GIBBSSAR
Amendment 15
Instruction Sheet

The following instructional information is being furnished to insert Amendment 15 into GIBBSSAR, the Gibbs & Hill Standard Safety Analysis Report.

FIGURE NO. 7.3-1 SH.2F

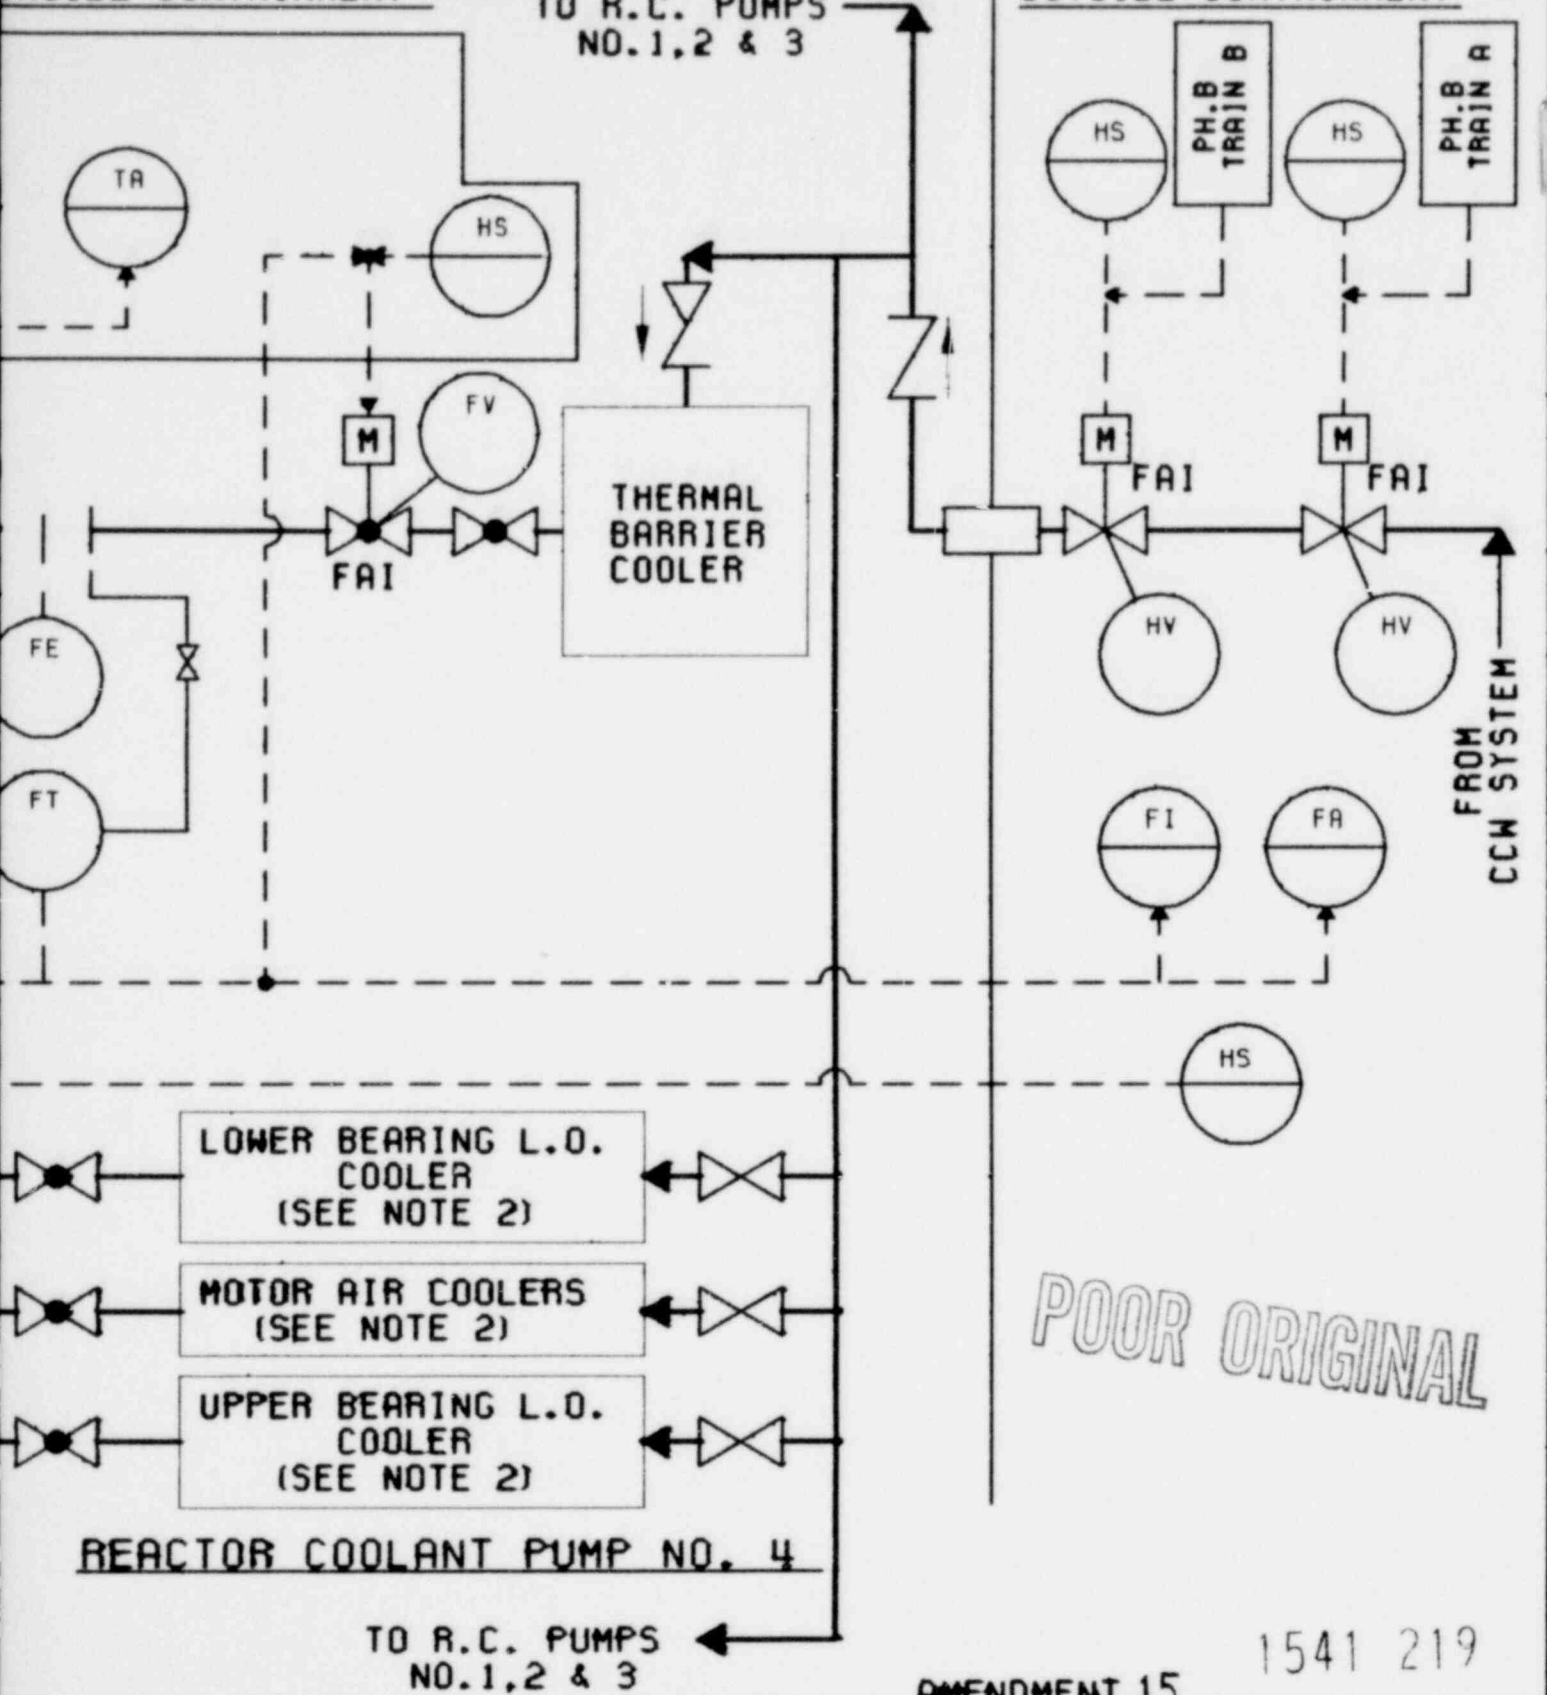
Table 9.2-10 of your PSAR regarding component cooling water interfaces is not complete. RESAR-414 also has interface requirements for the CCW to the RCP's identified in Section 5A of RESAR-414. Verify that your CCW design meets these requirements. Also discuss how your design meets the safety related interface requirements in RESAR-414, Section 5A, regarding protection against a pressurizer relief tank rupture disc missile.

The GIBBSSAR CCW system design meets the interface requirements for the CCW to the reactor coolant pumps identified in Section 5A of RESAR-414. See section 7.3.1.1.d, revised section 9.2.2.3, Table 9.2-10, and Figures 9.2-4, and 7.3-1 sheet 2F.

GIBBSSAR		1541 223
NSSS:		STANDBY DIESEL GENERATOR
NOT SPECIFIC		AUTOMATIC
W-414		STARTING & LOADING SEQUENCE
CE		
B&W		FIGURE NO. 8.3-2

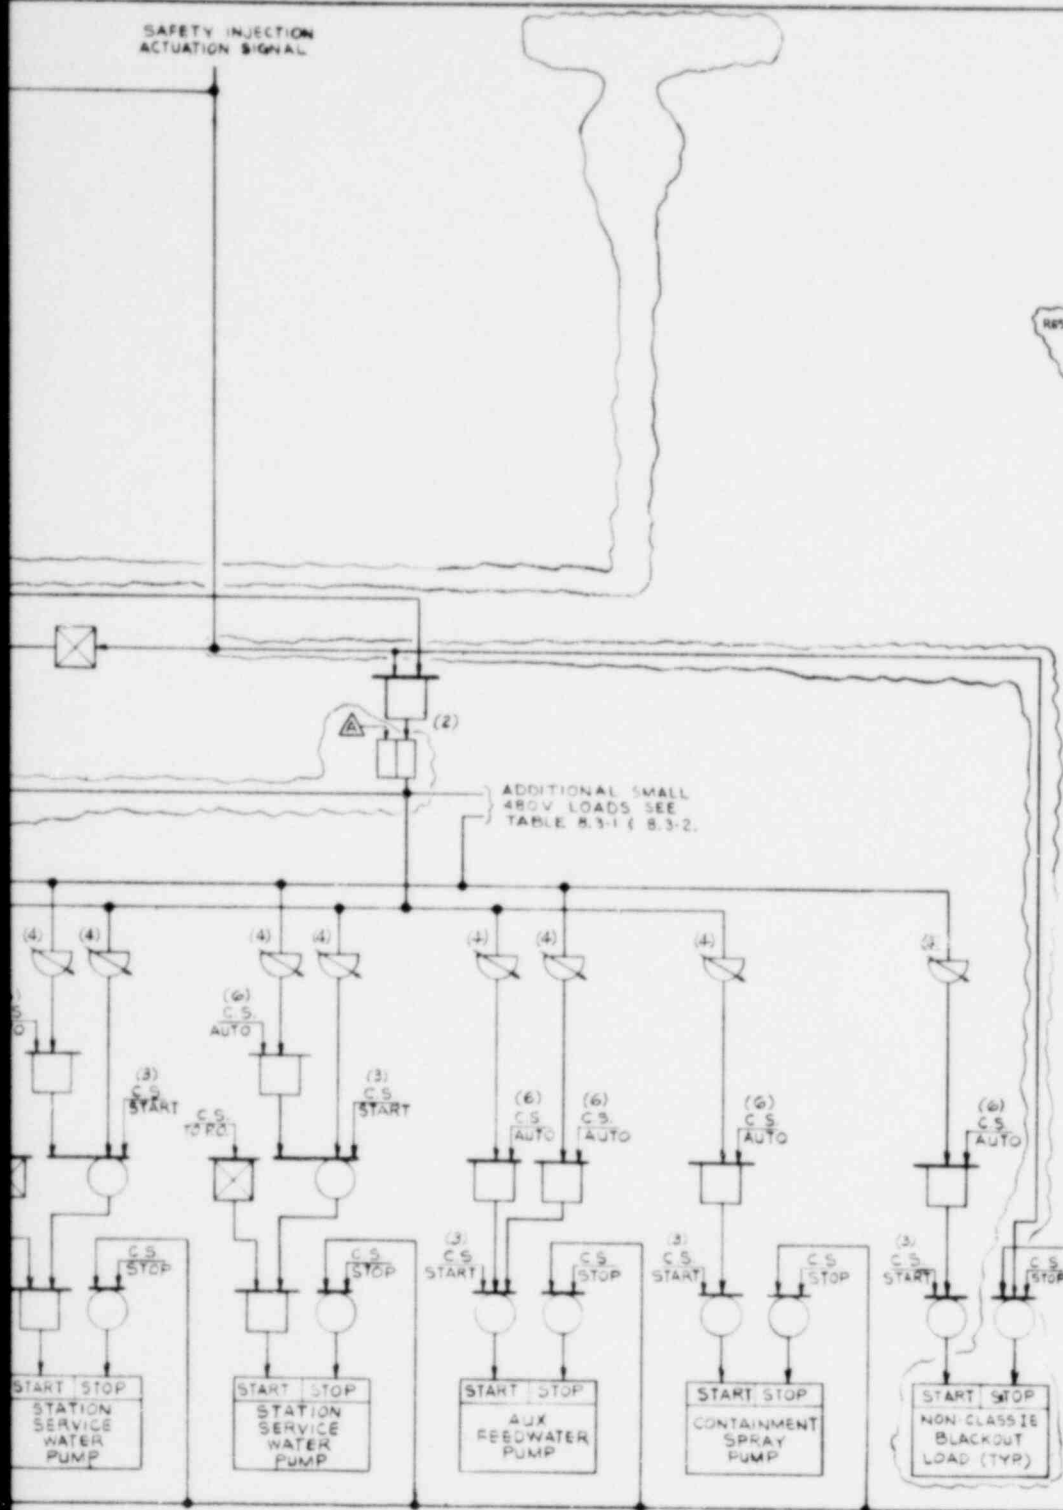
Your response to our question 040.4 (revised section 3.1.17) states that automatic sequencing of safety-related loads will be performed whether the ESF buses are powered from the onsite or offsite power sources. Expand your description of ESF load sequencing and address whether or not you employ independent or common load sequencers when using either onsite or offsite power sources. If common sequencers are used, provide a detailed analysis to demonstrate that there are no credible sneak circuits or common failure modes in the sequencer design that could render both onsite and offsite power sources unavailable. In addition, provide information concerning the reliability of your sequencers and reference design detailed drawings.

Your response to our question 040.11 included revisions to Section 8.3.1.1.b(8) and Figure 8.3-2. Explain the logic associated with the bus IAEI (System 1-loss of voltage) and (System 2-undervoltage) signals as these signals initiate load shedding, bus IAEI supply breaker tripping, and load sequencing. Figure 8.3-2 should show the option to sequence the ESF loads on either offsite or onsite power when a safety injection signal is received, load shedding associated with a safety injection signal with availability of offsite power and the load shed blocking logic (as explained in note 7). It is requested that system descriptions and detailed electrical control circuits for the standby DG automatic starting and loading sequencer system, including initiating circuits and load shedding and sequencing when offsite power is available, be provided for information.

See revised Figure 8.3-2 and Section 8.3.1.1.b(8).

See revised Figure 8.3-2 and Section 8.3.1.1.b(8).
